# Access Compliance Report

## Public Rights-of-Way

### (Curb Ramps)

Intersection ID: 10019272	Main Street: 3RD-4TH_CONNECTOR_ST	Cross Street: N/A	Location: W
ADA ID: 86923FE33BFB	Ramp Type: Perp	Initial Pass/Fail: Fail	Overall Compliance: No
Severity Score: 35			
Codes/Mitigation Info/Possible Solution		Field Measurements/Component Compliance

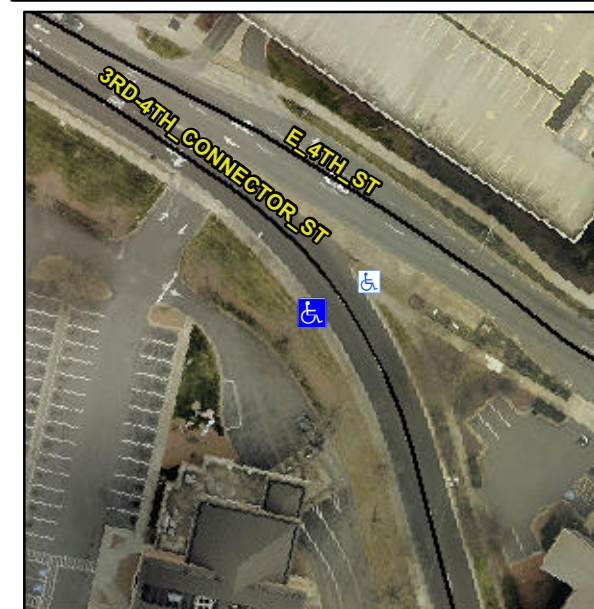
**Remove & Replace Entire Ramp.**

**R304.5.1, R304.2.2**

Compliance	Description	Data	Compliance	Description	Data
N/A	Ramp Length (in)	60.0	No	Ramp Slope (%)	12.7
No	Ramp Width (in)	44.0	Yes	Ramp XSlope (%)	3.7
N/A	Flare Type LT	N/A	N/A	Flare Type RT	N/A
N/A	Flare Slope LT (%)	N/A	N/A	Flare Slope RT (%)	N/A
N/A	Flare Traversable LT?	N/A	N/A	Flare Traversable RT?	N/A
N/A	Landing Length (in)	N/A	N/A	DWS Provided?	N/A
N/A	Landing Width (in)	N/A	N/A	DWS Contrast?	N/A
N/A	Landing Slope (%)	N/A	N/A	DWS Length (in)	N/A
N/A	Landing X Slope (%)	N/A	N/A	DWS Full Width?	N/A
N/A	Landing Curb? (Y/N)	N/A	N/A	DWS Offset (in)	N/A
N/A	Shared Landing?	N/A			
N/A	Gutter Ponding?	N/A	N/A	Gutter Slope (%)	N/A
N/A	Gutter Lip Ht (in)	N/A	N/A	Gutter X Slope (%)	N/A
N/A	Painted X Walk1?	No	N/A	Painted X Walk2?	N/A
	X Walk 1 Direction	To E		X Walk 2 Direction	N/A
N/A	X Walk 1 Width (in)	N/A	N/A	X Walk 2 Width (in)	N/A
	X Walk 1 Slope (%)	2.7		X Walk 2 Slope (%)	N/A
	X Walk 1 X Slope (%)	4.4		X Walk 2 X Slope (%)	N/A
